7.7 North East Link South Alliance Urban Design and Landscape Plan submission

The purpose of this report is to present the draft submission (**Attachment 1**) to the North East Link Eastern Freeway Upgrades - Burke Road to Tram Road Urban Design and Landscape Plan (UDLP) for consideration and endorsement.

North East Link Eastern Freeway Upgrades - Burke Road to Tram Road - Urban Design and Landscape Plan

Figure ~~20202020~~ Zone 3 of the Koonung Creek Reserve Concept Design

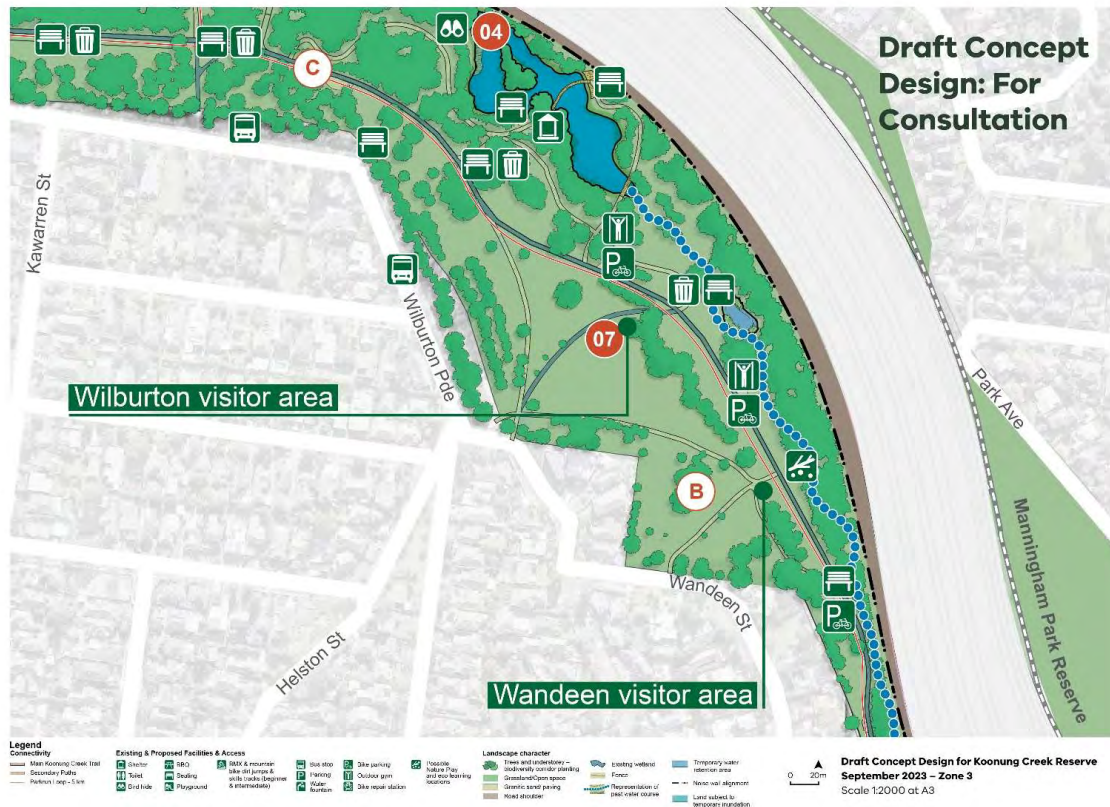
The below represents the feedback received on Zone 3:

5.2 Musca Street Reserve

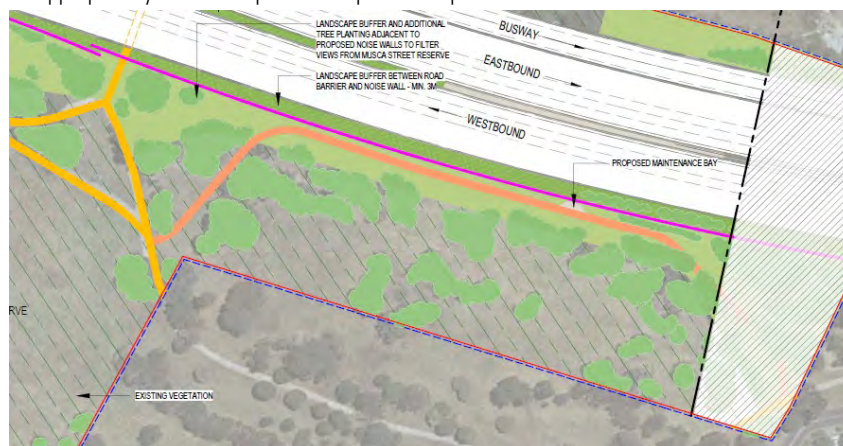
62. The encroachment of the freeway south into the open space illustrated on Landscape Drawing NO. 9536 is minimal and largely within the footprint of the existing freeway corridor. To the northwest portion of the open space, there appears to have been a gain of 2,752m² based on the difference between the existing fencing vs proposed noise wall alignment.

63. Despite this, considerable loss of vegetation is recorded along the northern edge of the reserve as per the Tree Removal & Reinstatement Plan snip below. It is understood that vegetation loss is linked to the construction of new noise walls. Given that the scale of Musca Street Reserve offers a generous buffer to residential land, it is recommended that the existing noise walls are retained if vegetation retention can be maximised.

5.4 Koonung Creek Reserve – East

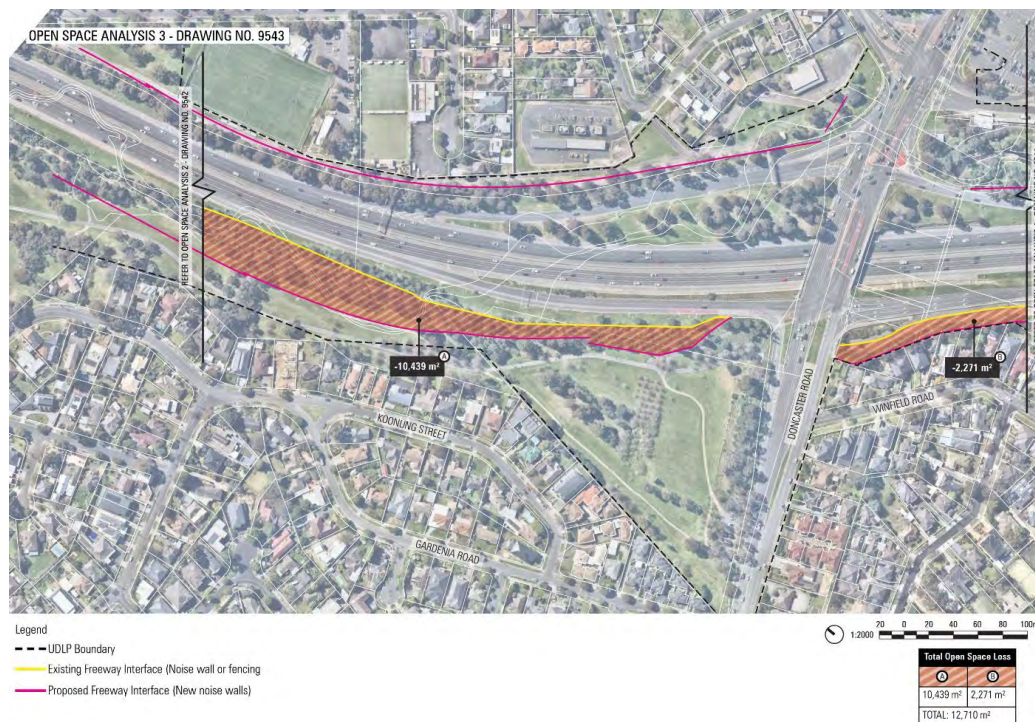
89. The encroachment of the freeway south into the open space illustrated on Landscape Drawing NO. 9536 is considerable, resulting in substantial loss of vegetation and informal open space with a strong riparian character. The southern encroachment recorded for this segment of Koonung Creek Reserve within the confines of Landscape Drawing 9543 is approximately 10,400m² of which is largely within the PPRZ.

90. To the eastern extent of Koonung Creek Reserve towards Doncaster Road sees considerable narrowing of the linear open space corridor and further loss of 'open' space to water storage infrastructure. While this eastern extent of the park is currently narrower relative to the broader open space to the west, it still caters to the trail and open areas for informal recreation activity. The southern encroachment of the freeway corridor sees a loss in these open areas, with the remaining cross section catering the trail, drainage swale and narrow segments of mixed grass, shrub planting and garden beds. The landscape plans illustrate generally little opportunity for tree plantings to screen proposed noise walls.

Doncaster Road Underpass

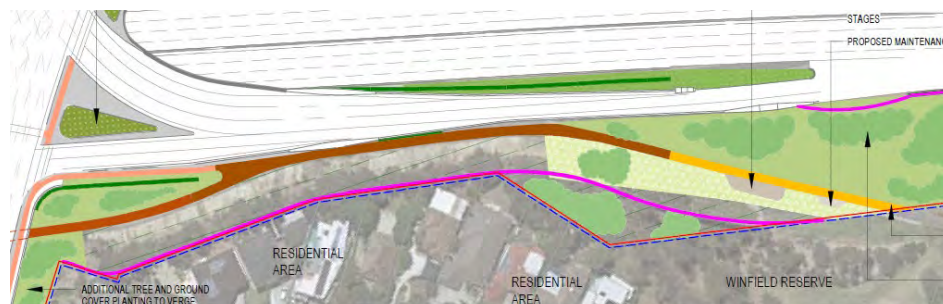
98. At the eastern edge of the reserve is the Doncaster Road underpass that is earmarked for upgrade. Proposed works are noted to include increased dimensions (to 7m wide), CPTED enhancements, functional and feature lighting and the application of brighter and textured materials to minimise darkness and the sense of enclosure.

Figure 20 Zone 3 of the Koonung Creek Reserve Concept Design

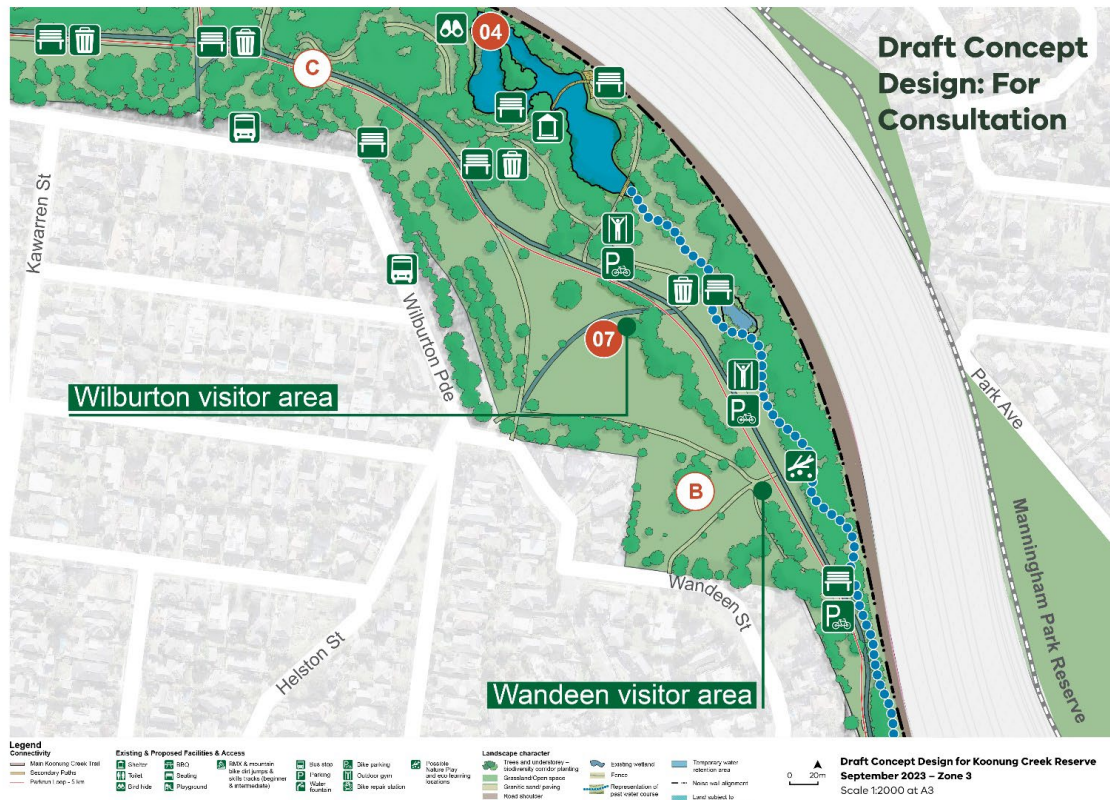
The below represents the feedback received on Zone 3:
